Major Site Plan Application

RE: Major Site Plan Application - Resubmittal
H2OBX RV Resort
Currituck County, North Carolina

POST DEVELOPED DRAINAGE AREA MAP
H2OBX RV & WATERPARK RESORT
H2OBX, LLC
CURRITUCK COUNTY
POPLAR BRANCH TOWNSHIP
NORTH CAROLINA

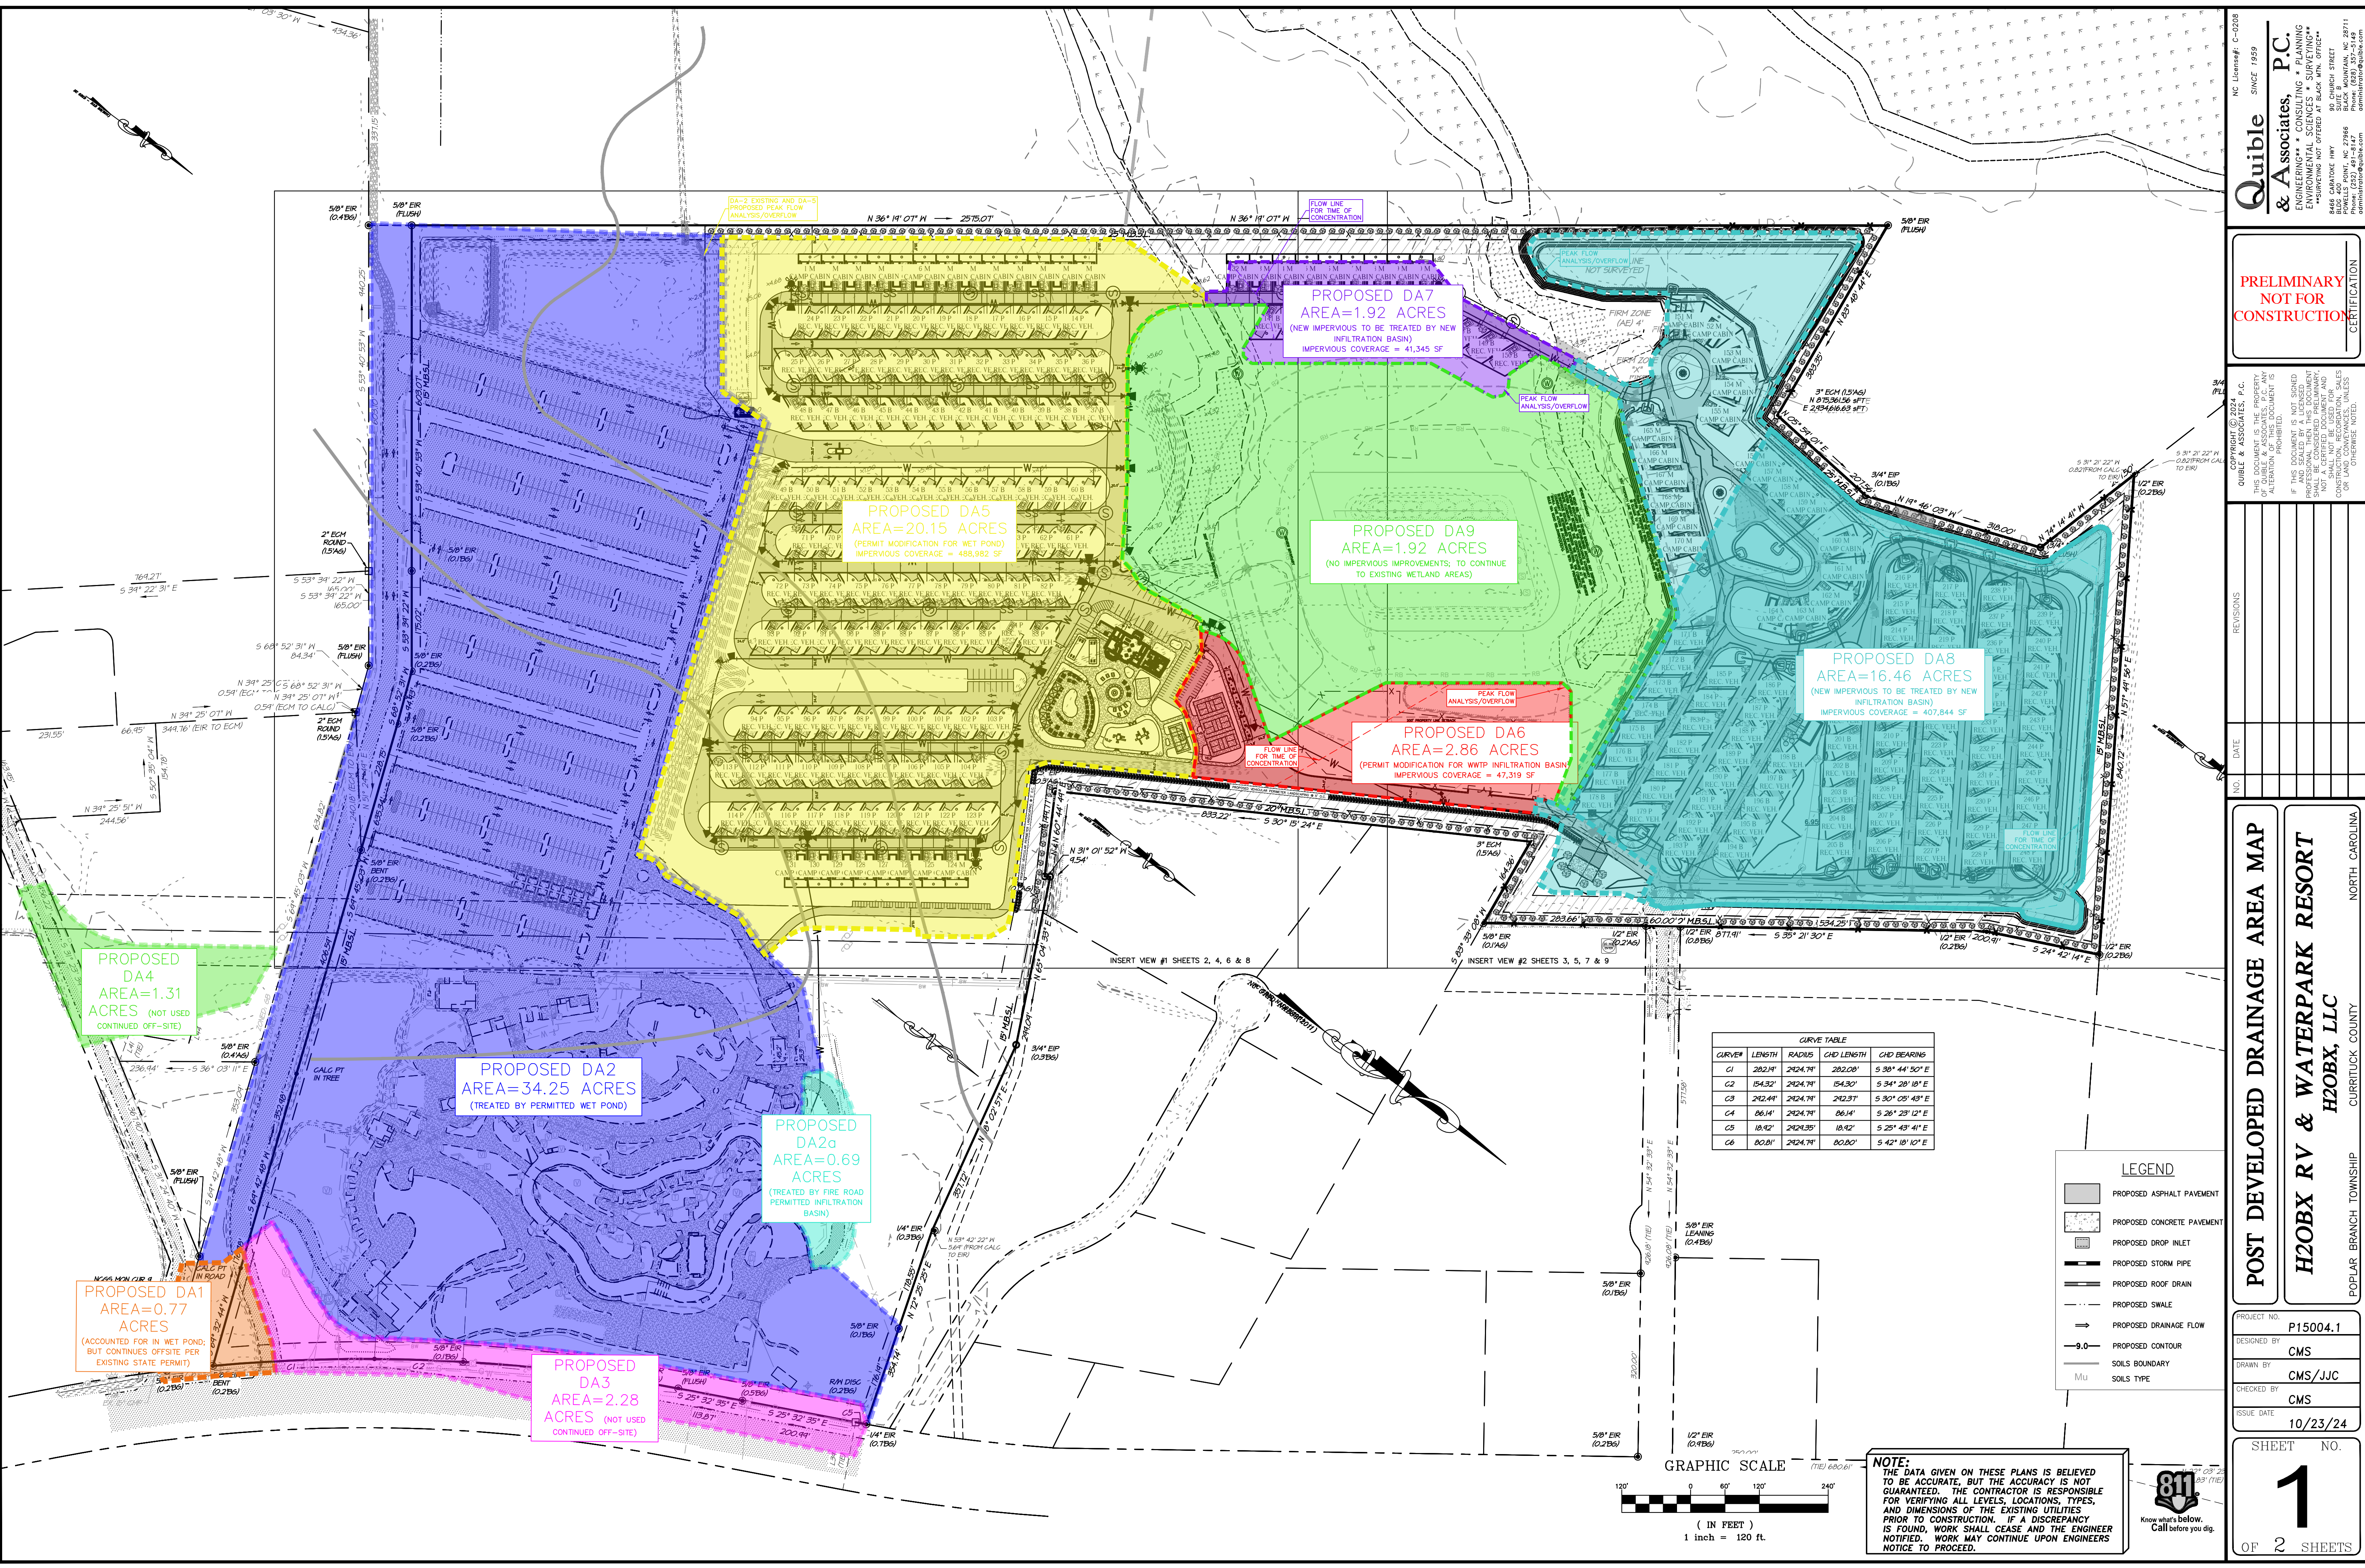
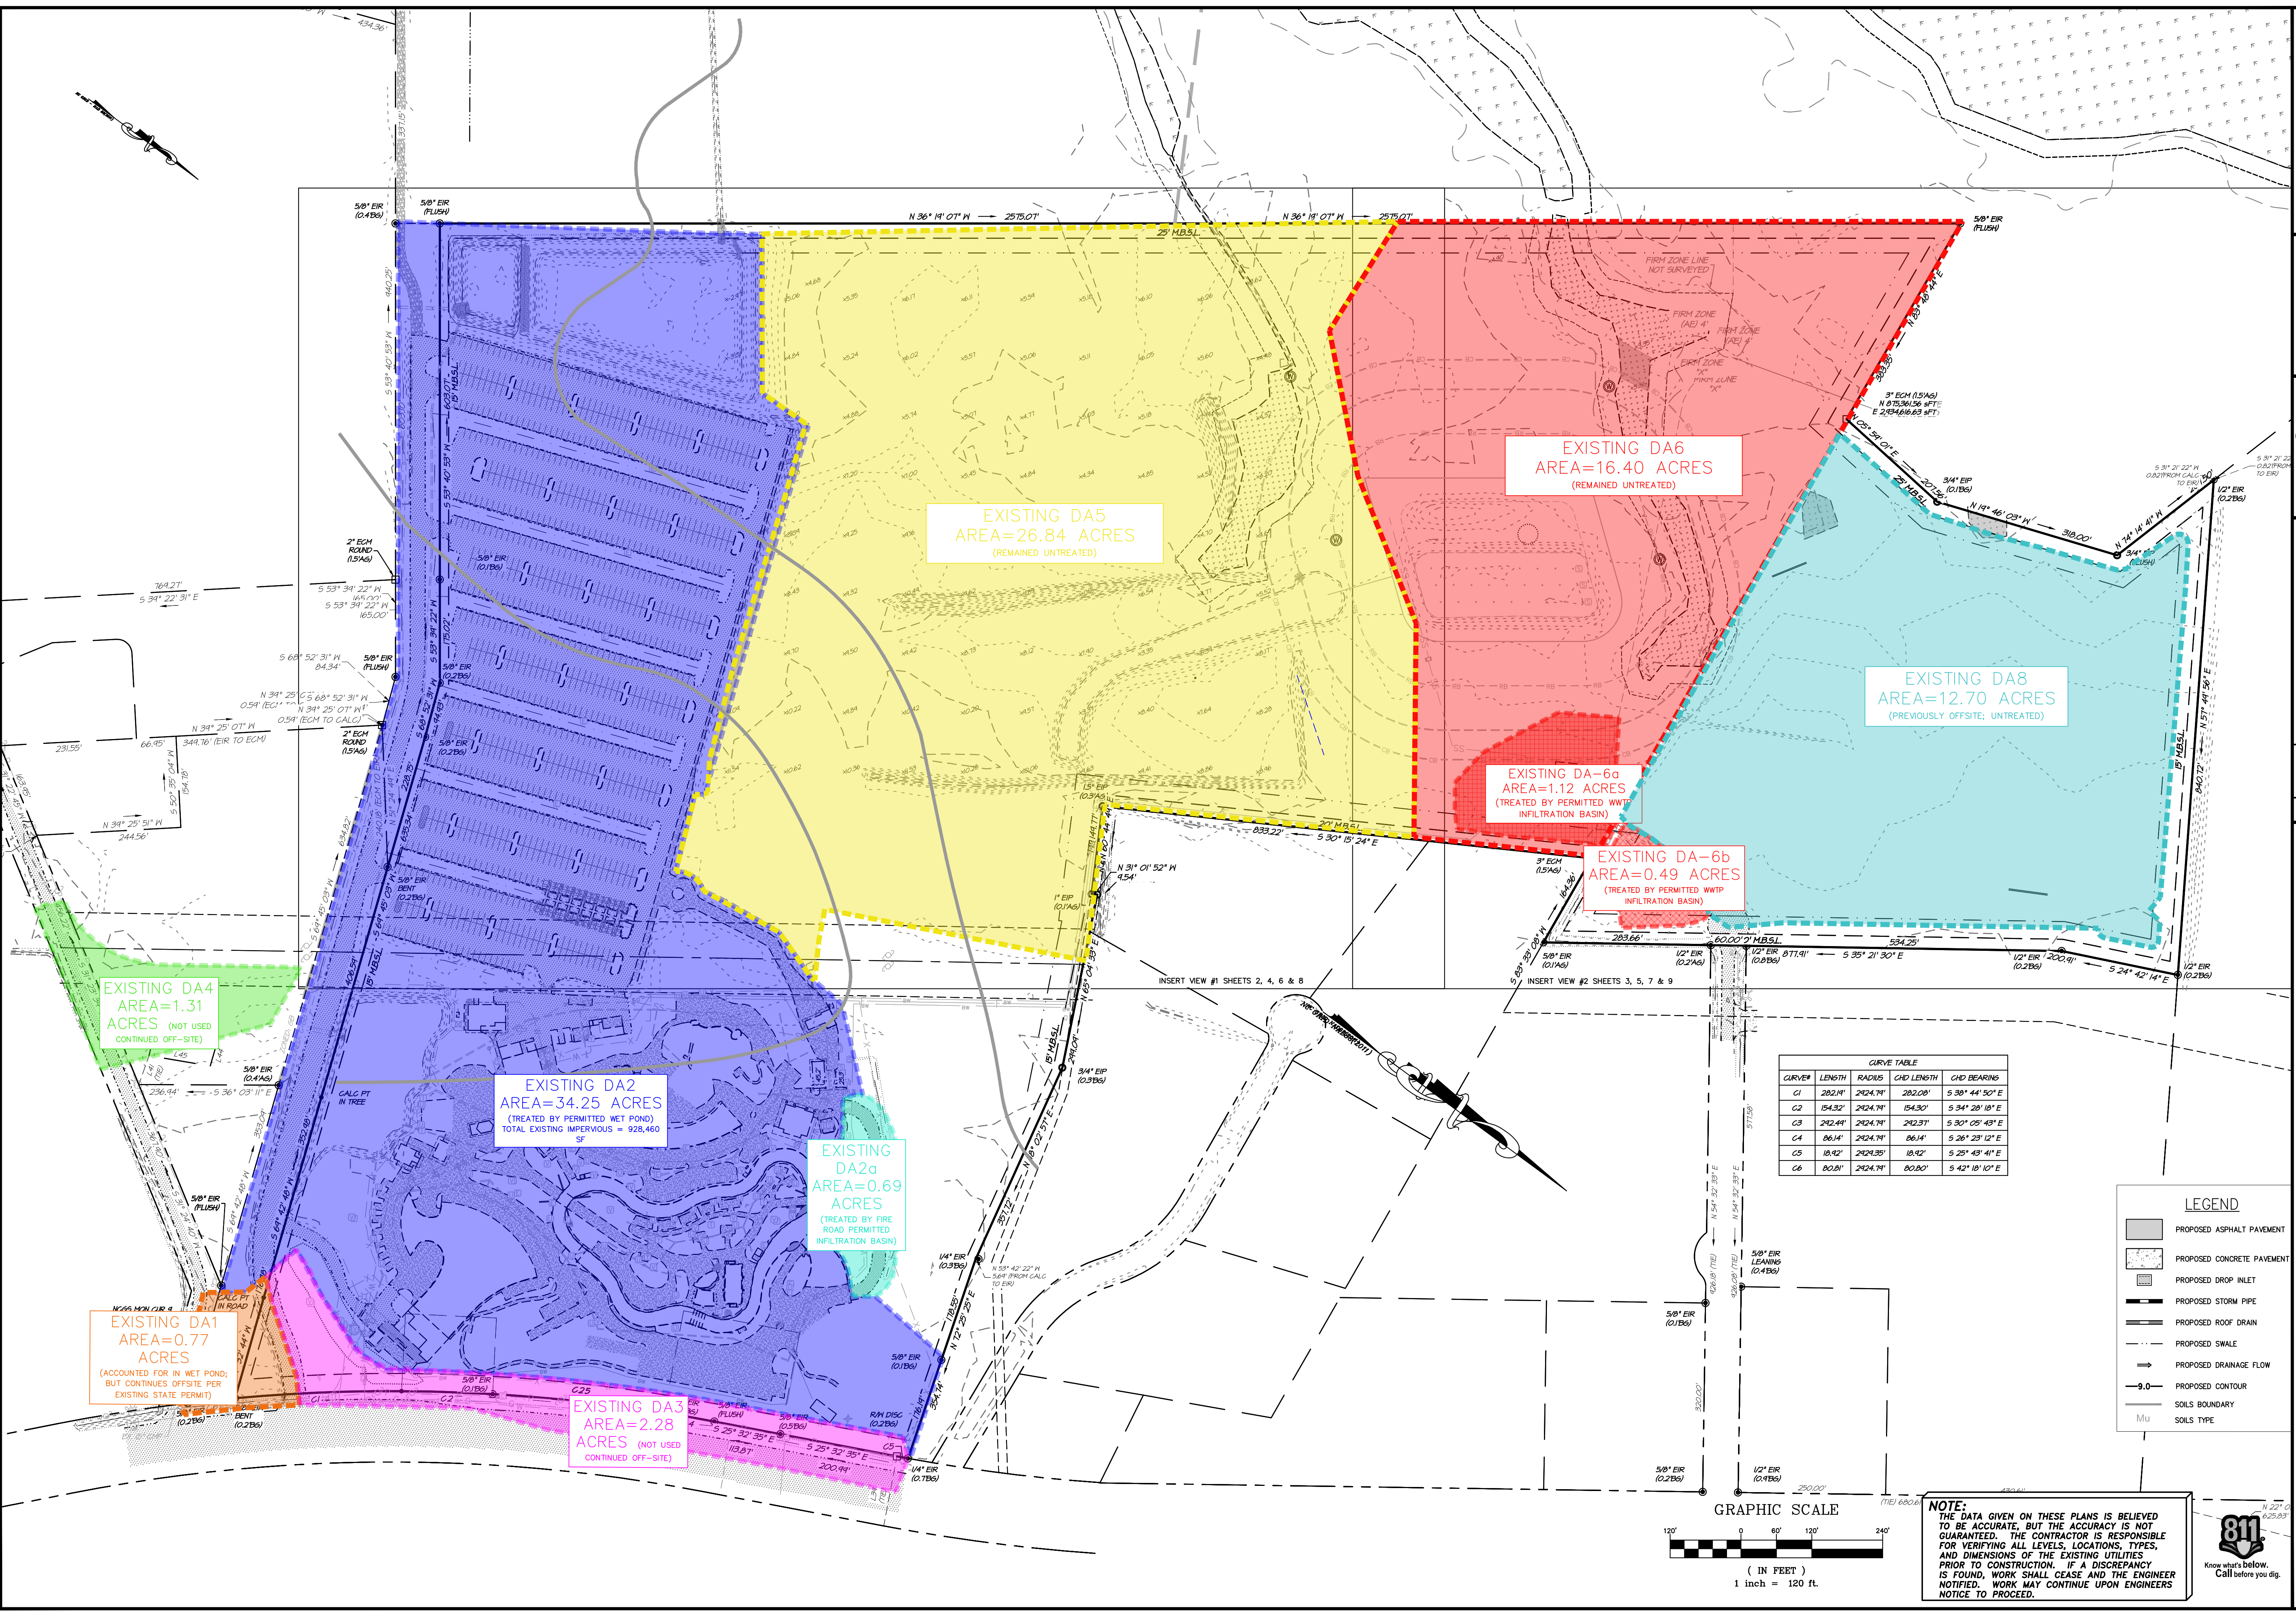
1. Please provide a map indicating the locations where peak flow analysis is taking place. *Please see drainage area maps for peak flow analysis locations.*

2. Please provide more detailed quantification of impervious for existing and proposed conditions. *Please see drainage area maps for additional information on proposed impervious coverage.*

7. Please provide a drainage area map with clear delineations of which areas are draining to which SCMs, including callouts for quantities of cover conditions for each drainage area, as well as existing and proposed contours and time of concentration paths. It is currently unclear which areas are draining to which SCM. *Acknowledged. This has been provided.*
8. Please provide a soil map. It is missing from Appendix 3. *Acknowledged. The soil map has been included.*
9. Please provide locations and dimensions, including invert elevations, of outlet structures within the SCMs. *Acknowledged. This has been provided. Please note the overflow within the*
